Notification No.: 20140801

Description: iVIZION® Motor Gear Assembly

Hardware: Motor Gear Assembly

Figure 1: iVIZION Unit Motor Gear Assembly

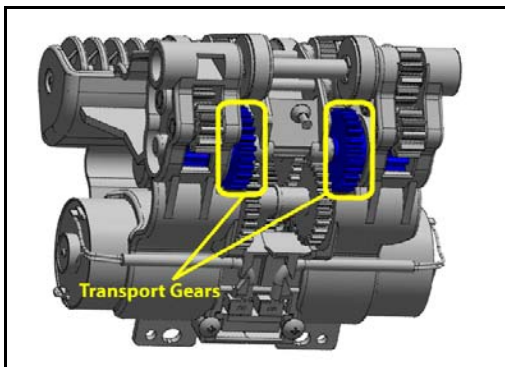
JCM Engineering has received field reports of reduced Barcode Ticket Acceptance on iVIZION® Units in high usage environments, such as kiosks and ticket redemption machines.

An investigation by JCM Engineering determined excessive wear on the iVIZION Motor Assembly Transport Gears (Figure 1) may cause inconsistent drive belt movement after 250,000 to 300,000 cycles. JCM Engineering has modified the Transport Gear design as shown in Figure 2 for improved performance, and recommends replacement of these gears if the above conditions are identified. Refer to Section 4 of the iVIZION® Series Operation and Maintenance Manual (JCM Part Number 960-100929R) for Disassembly/Reassembly Instructions for the Motor Gear Assembly. Note: As a courtesy to our customers, JCM has modified its standard production to include this new gear beginning with Production Serial No. 1406208375.
